**Wildflower
Village Plan Area 1
Tuesday, October 18, 2016
Public Hearing**

Report Date:	Monday, October 10, 2016
Applicant:	Nathan Shipp, DAI Utah
Owner:	Sunrise 3, LLC; WFR 3, LLC, Easy Peasy LLC
Location:	1 mile west of Redwood Road; West and North of Harvest Hills
Major Street Access:	State Road 73, future: Redwood Road and Mountain View Corridor
Parcel Number(s) & Size:	58:021:0143, 157.137 acres 58:022:0133, 2.068 acres 58:021:0024, 4.50 acres Total: 163.185 acres (application describes 168.59)
Parcel Zoning:	PC
Adjacent Zoning:	RC, A, R-3, R-14, R-18
Current Use of Parcel:	Vacant
Adjacent Uses:	Residential, Vacant
Previous Meetings:	Gilead Rezone/Master Plan application submitted 2011; not finalized. PC and CC Hearings & Meetings on Rezone / CP, 2014 and 2015 PC Public Hearing on Village Plan 1, September 22, 2016
Previous Approvals:	Community Plan Approval, February 24, 2015
Land Use Authority:	Council
Type of Action:	Administrative
Future Routing:	None
Author:	Kimber Gabryszak, AICP

Author: Gordon Miner, City Engineer
Subject: Wildflower Village Plan
Date: September 8, 2016
Type of Item: Village Plan Approval

SECTION 10b: Secondary Water Plan

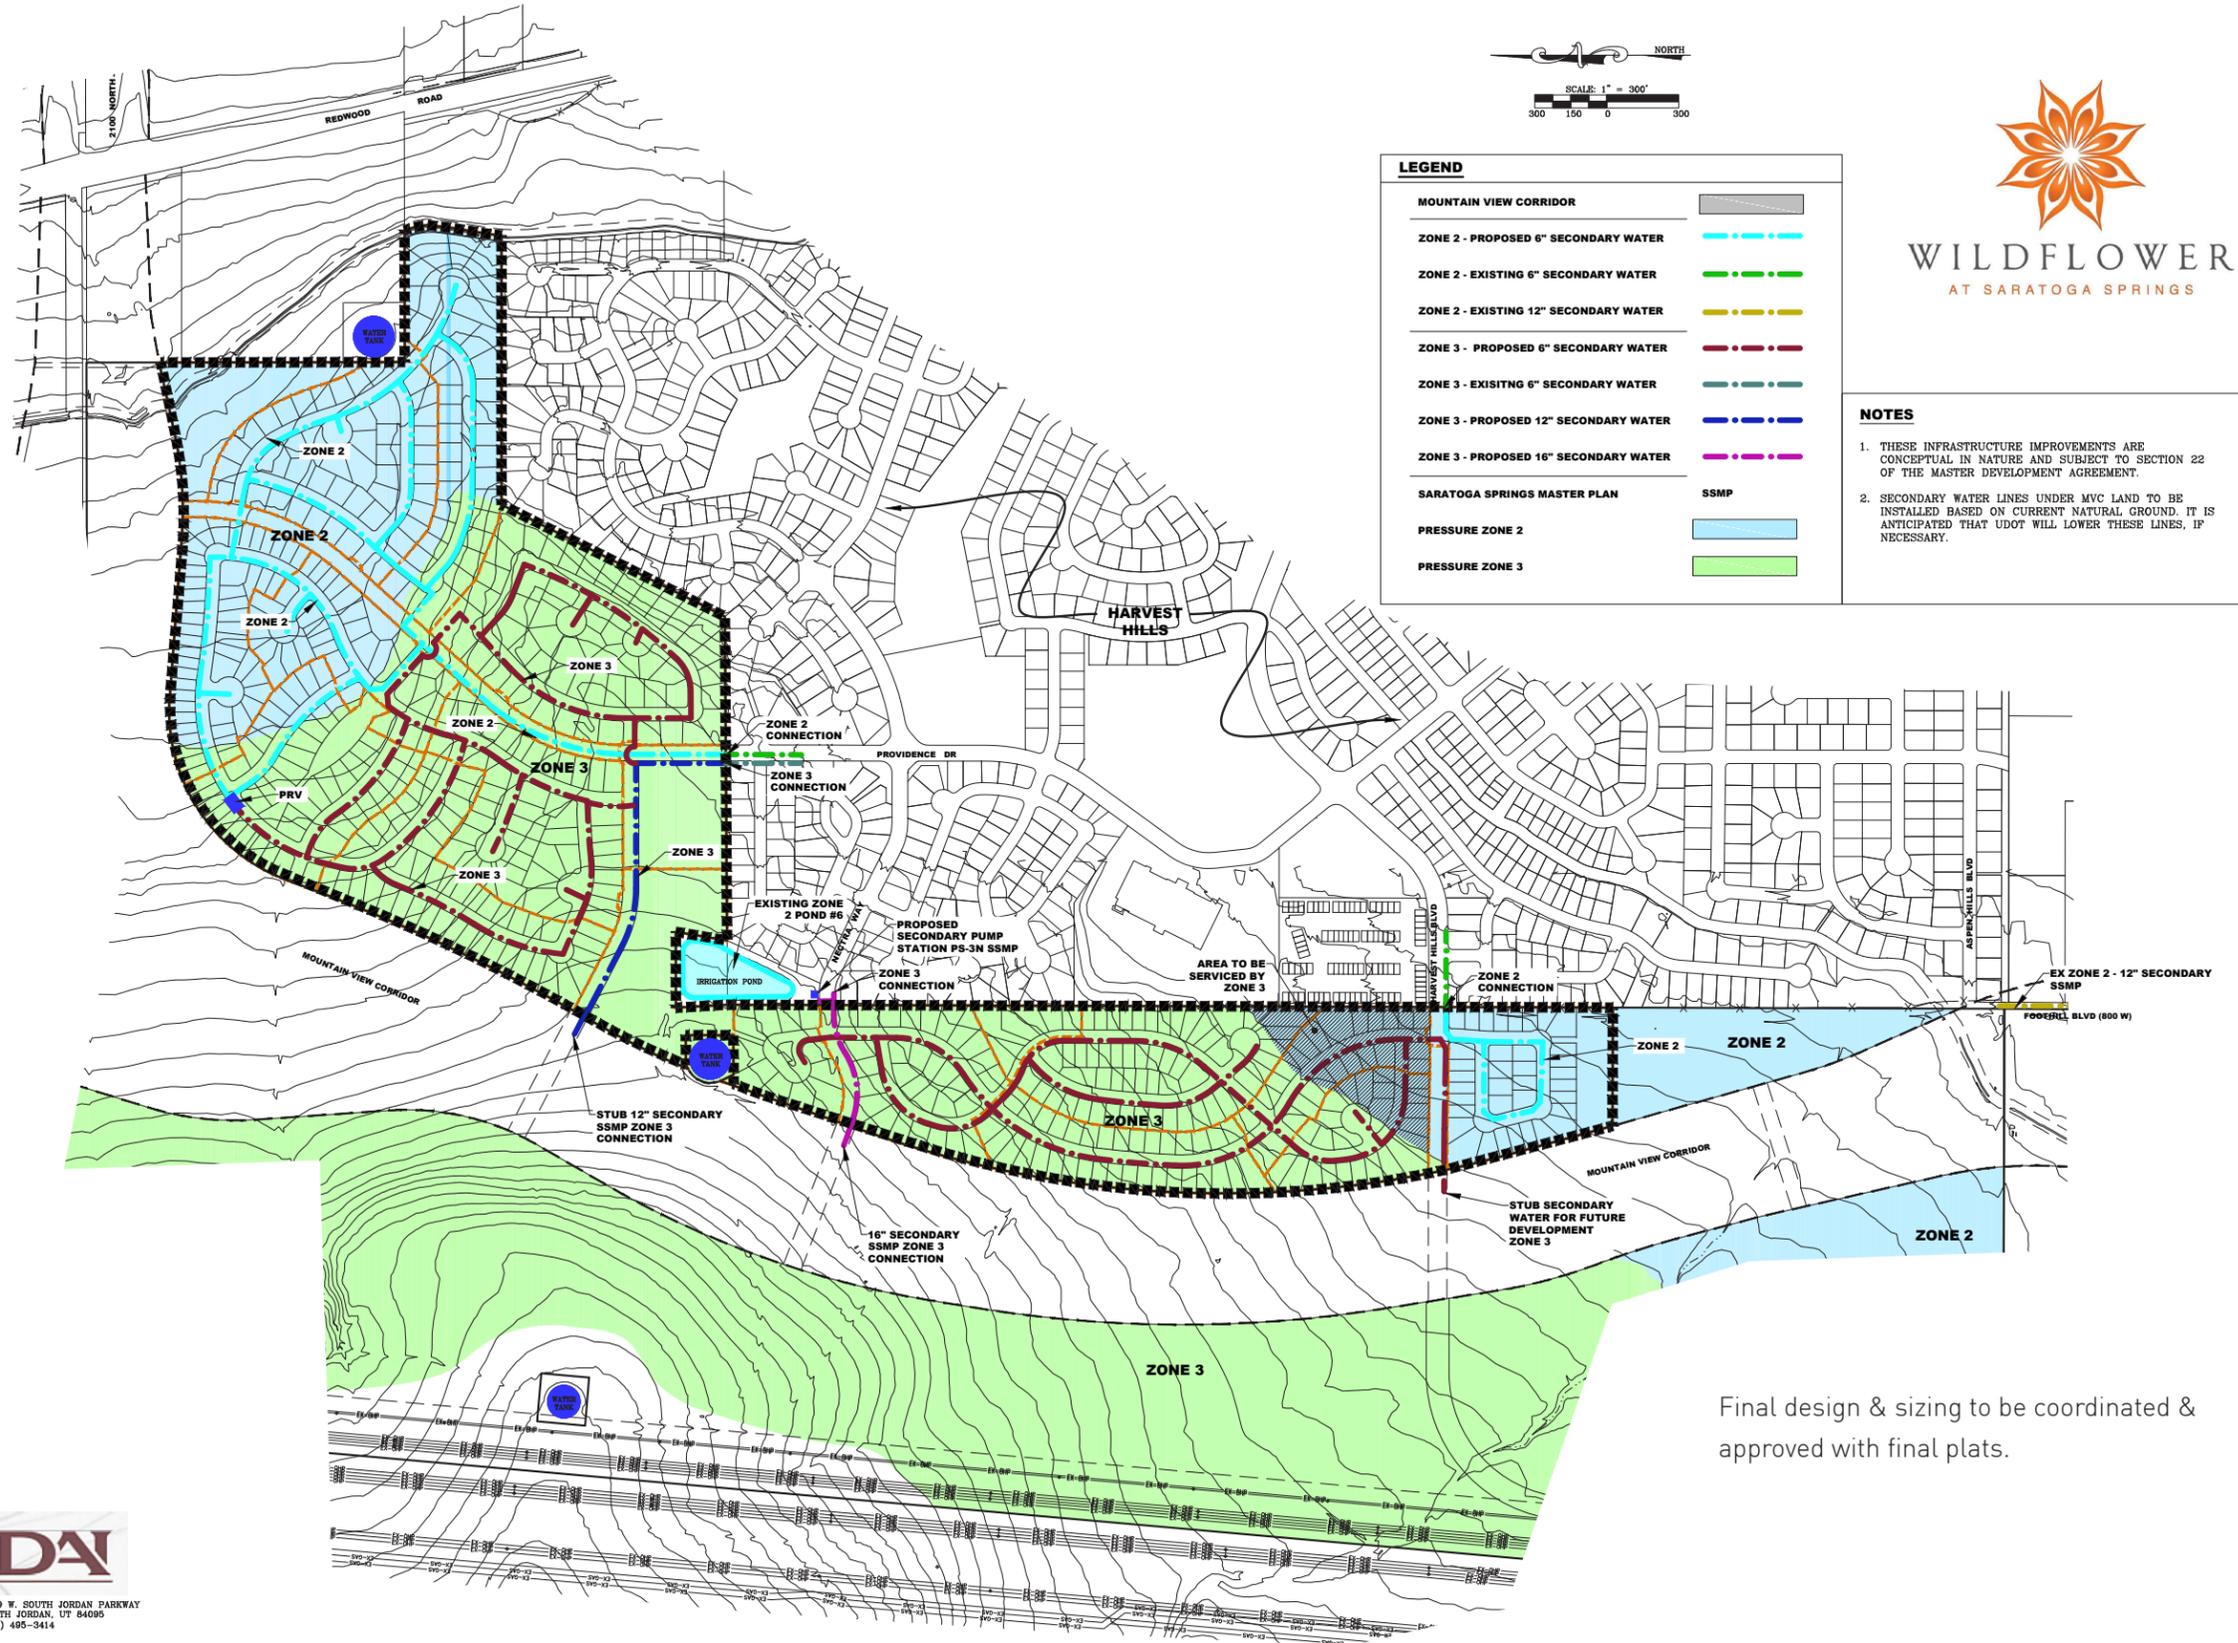
17. The pipe network for the Zone 3 secondary system shall be displayed in its entirety for Village Plan Area 1, including points of connection to the proposed Zone 3 pond and points of connection to existing zone 3 piping.

SECTION 10c: Sewer Plan

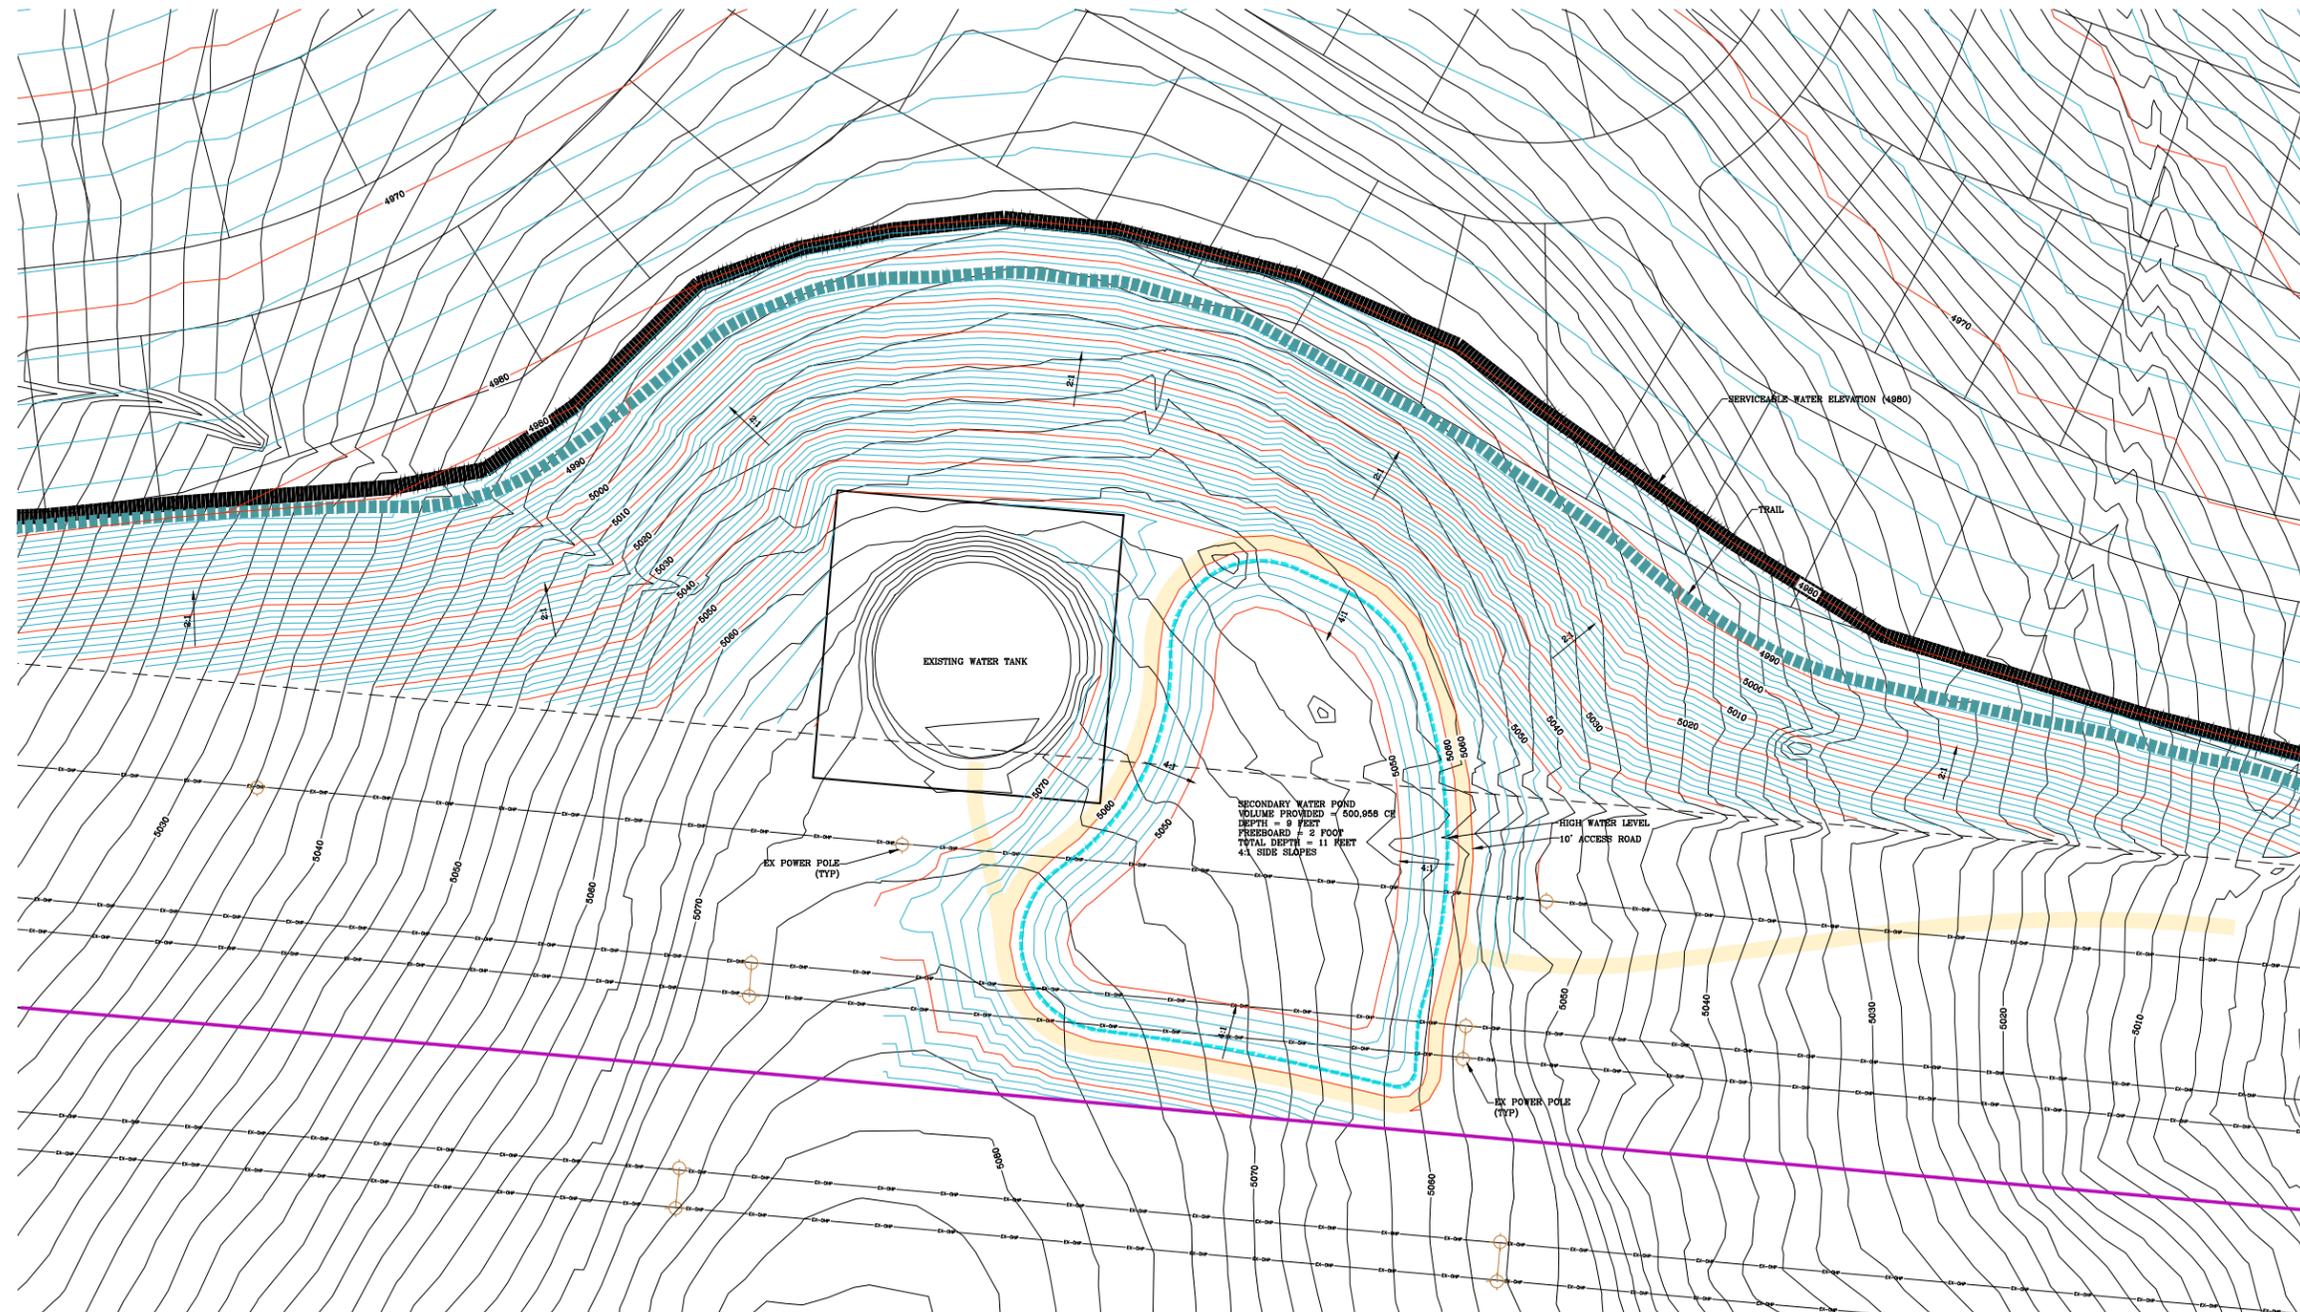
18. On Sheet S10-9 the N4 sewer trunk line from the City's Sewer Masterplan shall be discussed in a note. The Technical Memorandum from Bowen & Collins mentions on page 5 "if the Aspen Hills Blvd and Golden Rod Way sewer mains are upgraded to accommodate future flows, it may be possible to eliminate the future N4 trunk line.

SECTION 10e: Capital Facility Upgrade Plan

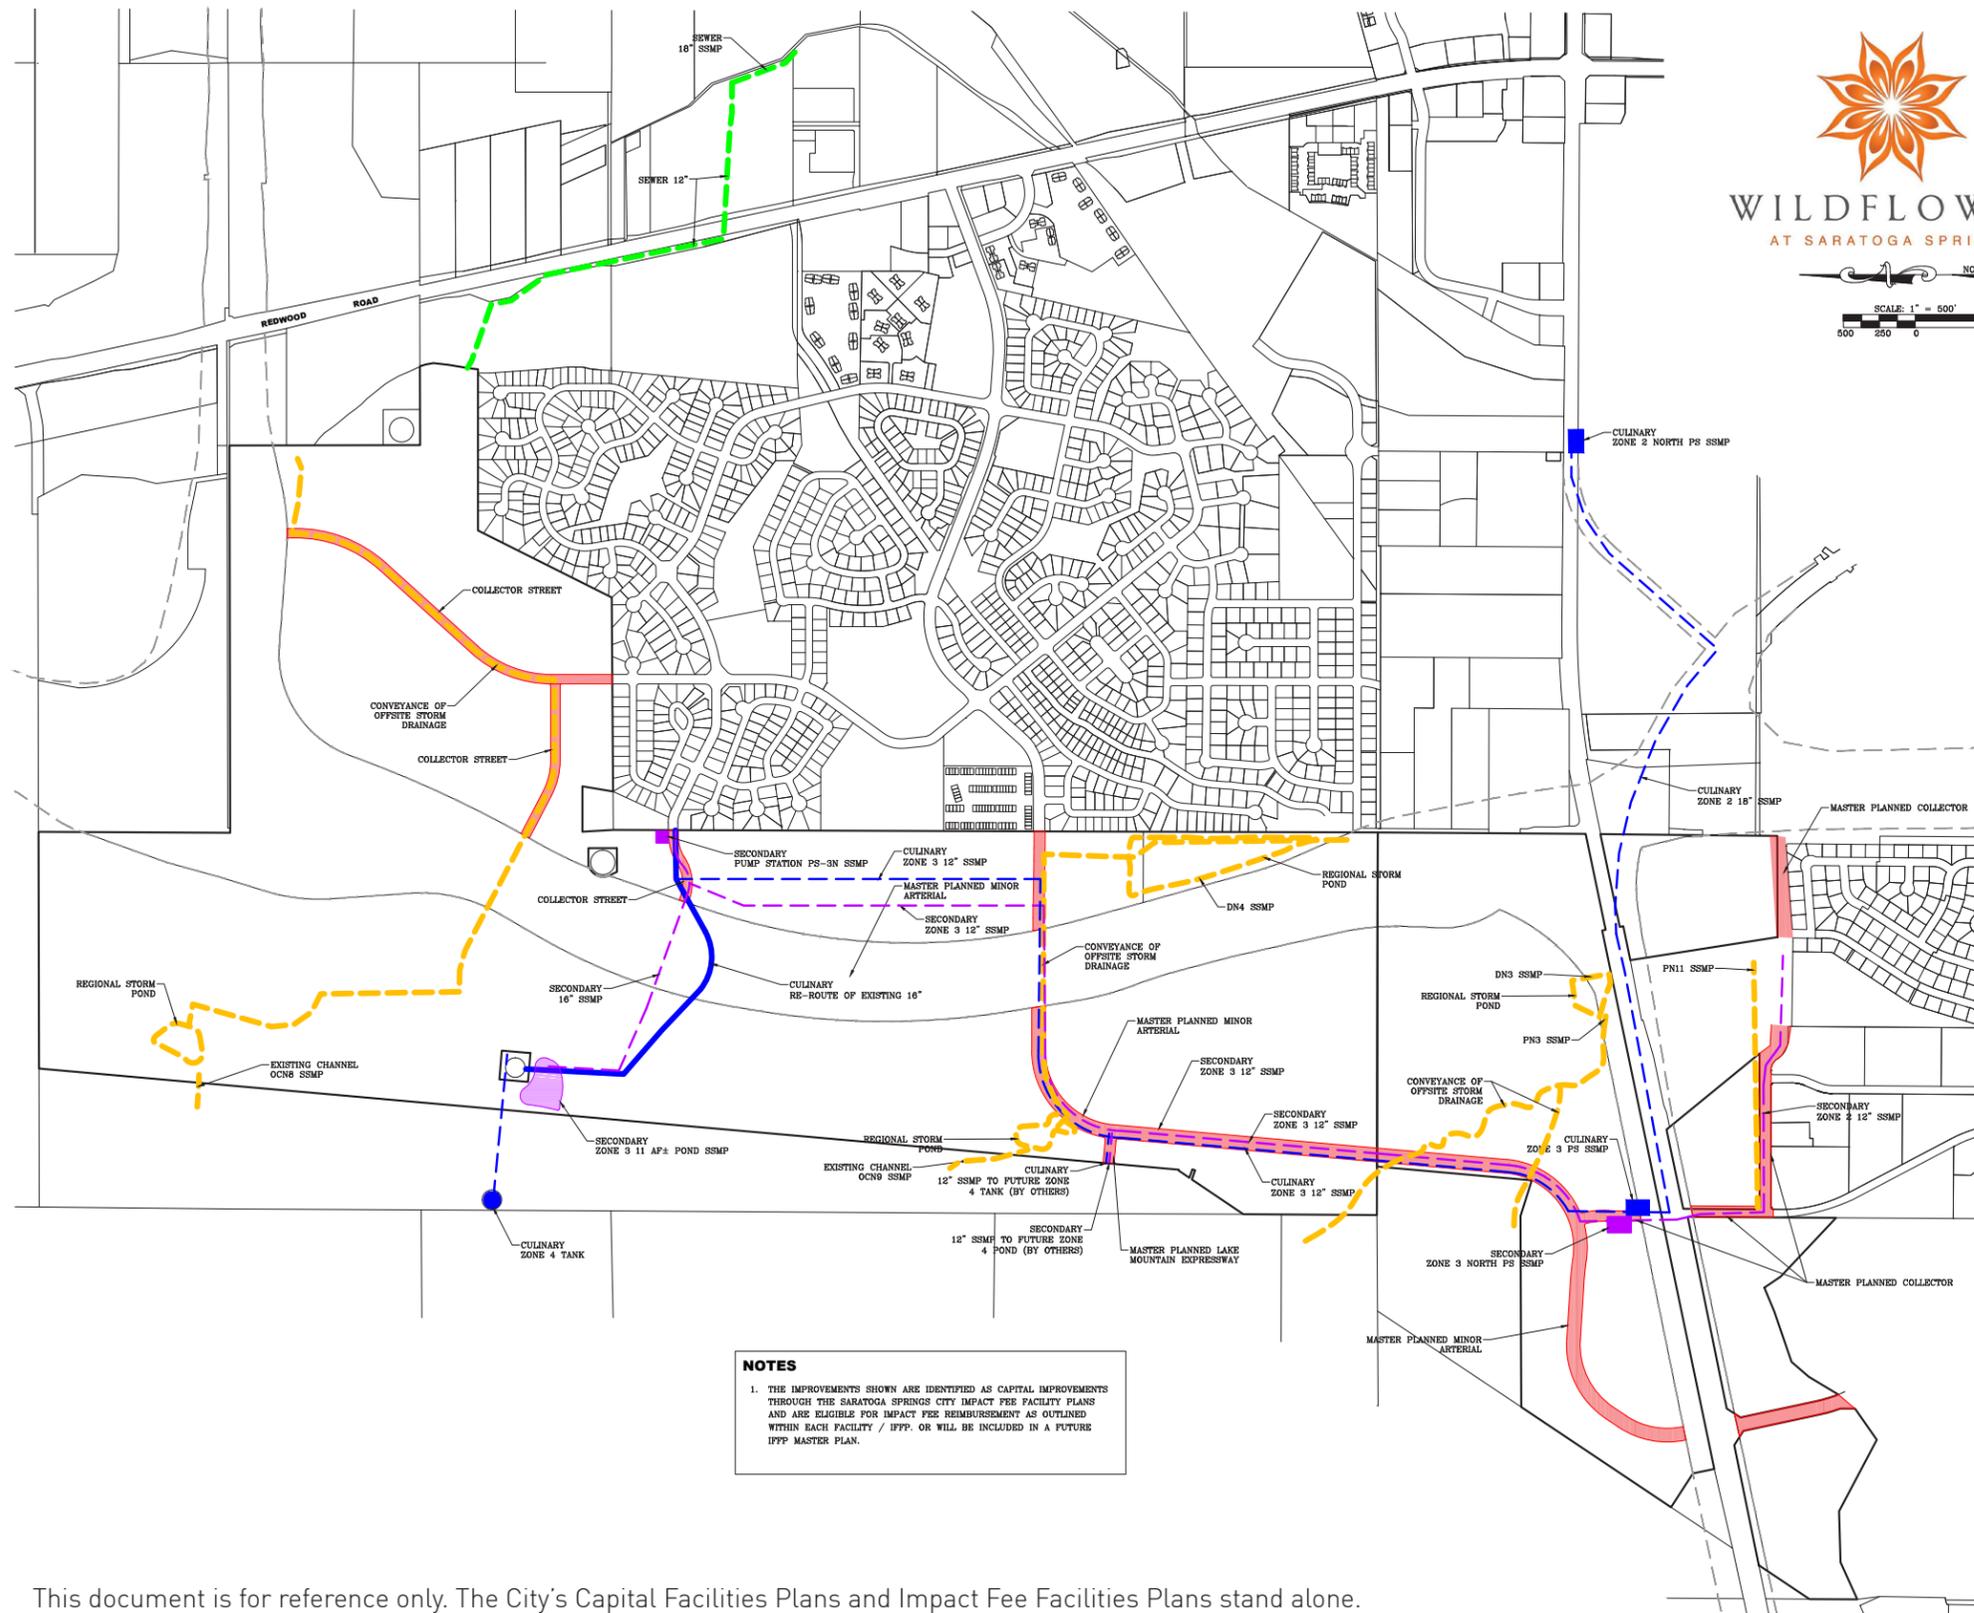
22. Manage the runoff of the 100-yr. storm event.
23. Drainage into the canal shall not be permitted.
24. On the sheet titled "Capital Facility Upgrade Plan" include the following note, "This document is for reference only. The City's Capital Facilities Plan and Impact Fee Facilities Plans stand alone."

This document is for reference only. The City's Capital Facilities Plans and Impact Fee Facilities Plans stand alone.
